# Project Concept Alternatives Considered and Not Pursued

## APPENDIX D

### Comments on Draft Concept Plan Report

Reference: San Ysidro Port of Entry Reconfiguration Mobility Study

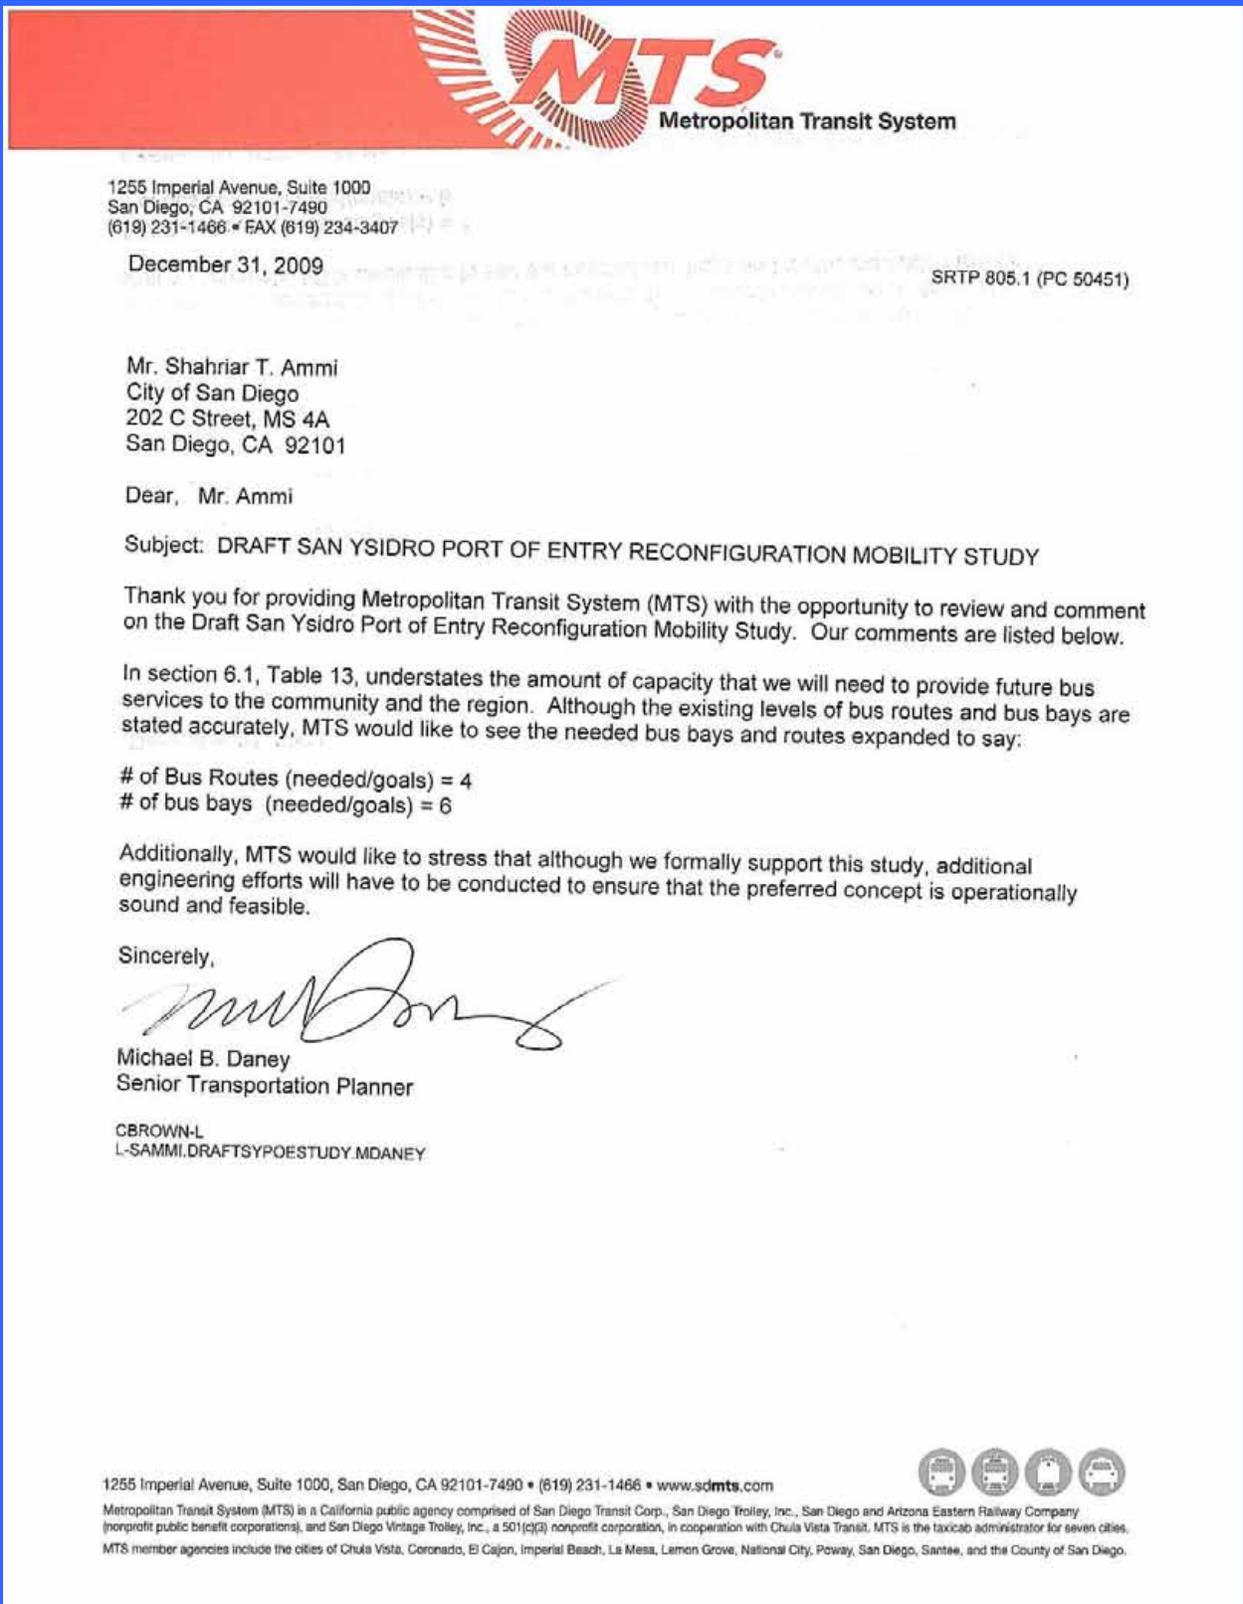
- Page 2 last paragraph, please substitute Caltrans planning grant, with ...“this study is funded through the Caltrans Transportation Planning Grant Program under Community Based Transportation Planning (CBTP).”

- As noted on page 102 under section 7.1 REMAINING ISSUES, Please add the following sentence at the end of this paragraph, "All alternatives will need to be evaluated in a Project Initiation Document for engineering validity, following Caltrans guidelines." to read... “Caltrans Design Exceptions – The conceptual site design for reconfiguration of border circulation and transportation facilities includes potential relocation of the northbound I-5 on- and off-ramps from the center of the Focused Study Area to a connection with Camino de la Plaza. At an August 10, 2009 meeting, Caltrans staff reviewed the ramp relocation proposal and indicated that there do not appear to be any fatal flaws with the concept. However, design exceptions to Caltrans highway design standards may be required. The extent of these exceptions will not be known until conceptual and preliminary engineering design is performed and design plans can be analyzed. All alternatives will need to be evaluated in a Project Initiation Document for engineering validity, following Caltrans guidelines.”
